RESPONSE TO REQUEST FOR ADDITIONAL INFORMATION - DA2019/1190

We write to you on behalf of the Manly Warringah Sea Eagles (**MWSE**) as the applicant to DA2019/1190 which seeks consent for the construction of a new grandstand and centre of excellence (**COE**) on the northern end of Brookvale Oval, located on Pittwater Road, Brookvale.

The purpose of this letter is to respond to the request for additional information received from Northern Beaches Council (**the Council**) on the 31 January 2020. The letter provides a detailed justification for the proposed location of the development, in conjunction with responses to all points raised by the Council.

Figure 3 Glazing Updates

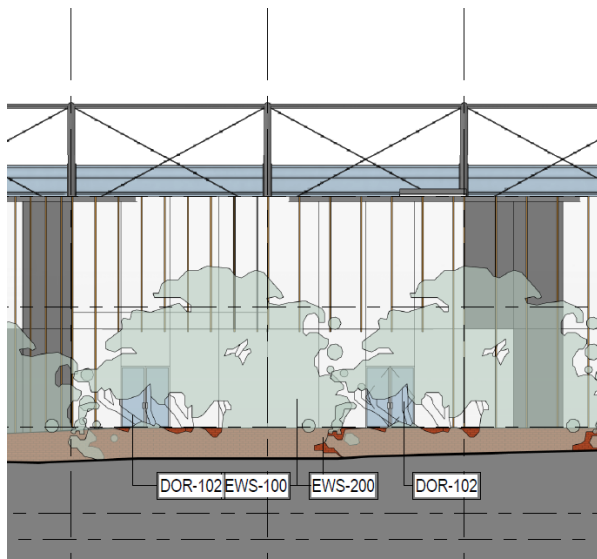
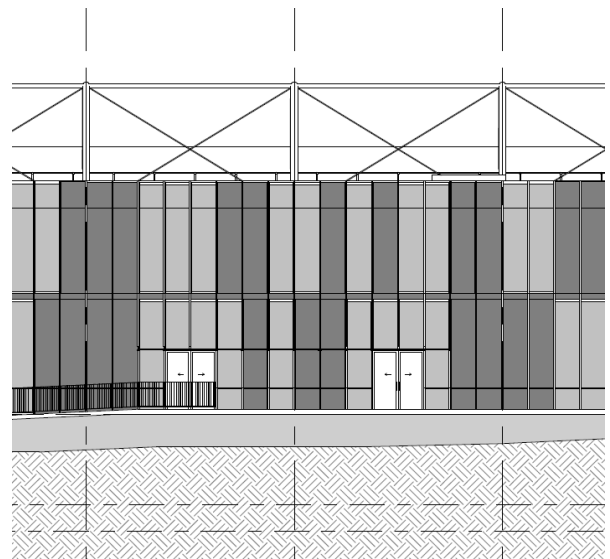
- Amount of glazing on north façade at entry lobby reduced, as shown in **Figure 3** below.

Figure 4 Vertical battens updated

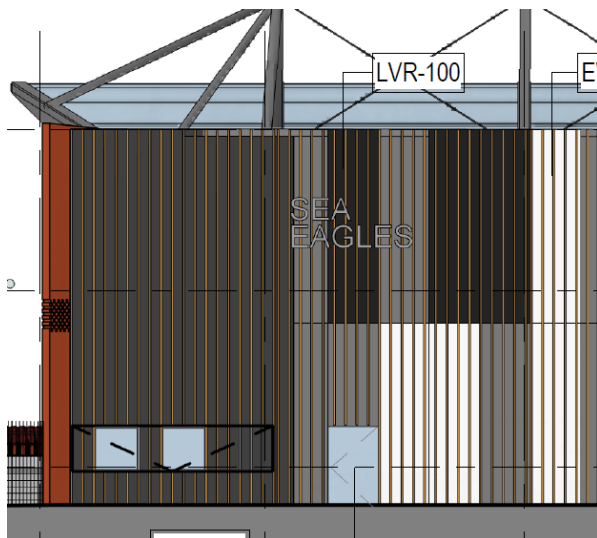
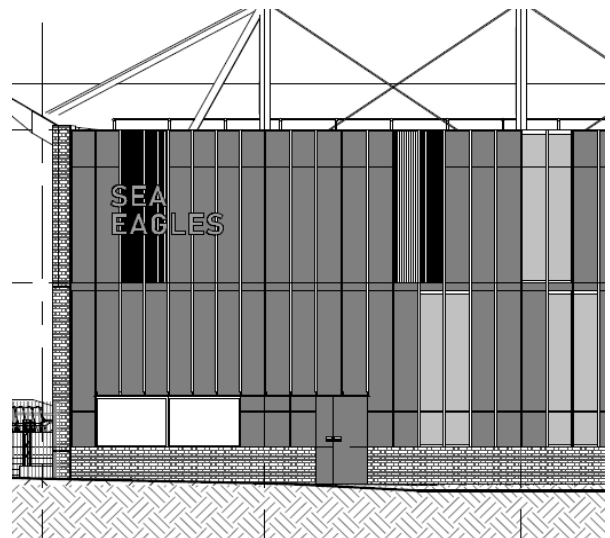
- Density and set-out of vertical battens updated and reduced along the northern facade, particularly towards the ends of the building. This is shown below in **Figure 4**.

Figure 5 Protruding brick wings removed (updated plan on the right)

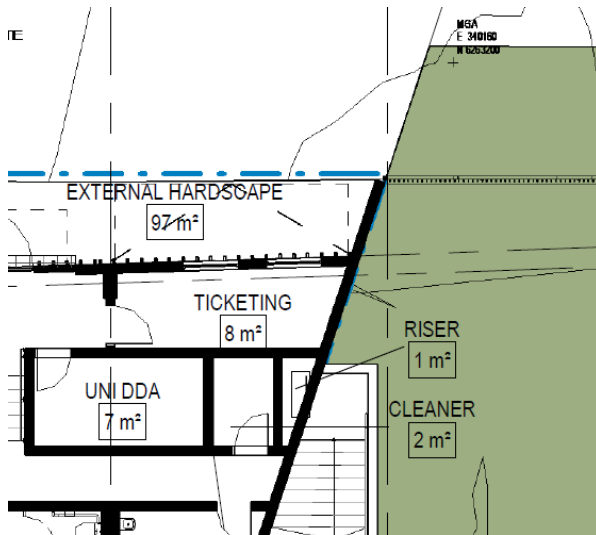
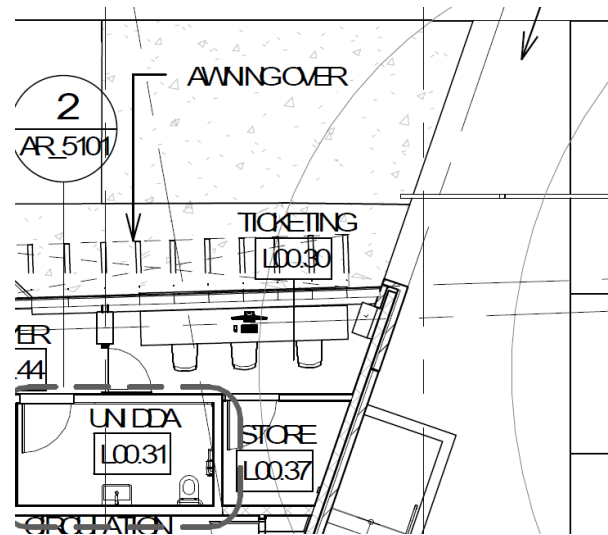
- Protruding brick wing walls in north-east and north-west corners removed, shown below in **Figure 5**.

Figure 6 Brickwork updated (east shown)

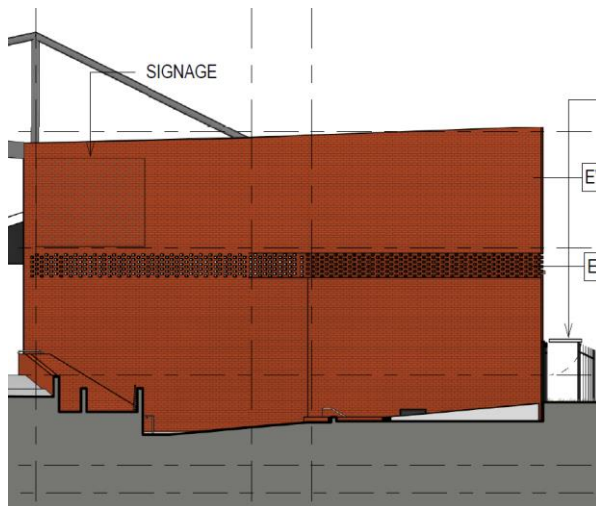
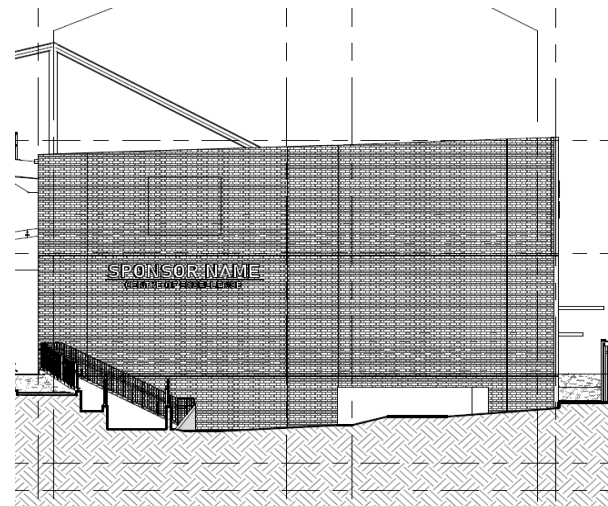
- Hit-and-Miss brickwork on east and west facades removed, shown below in **Figure 6**.
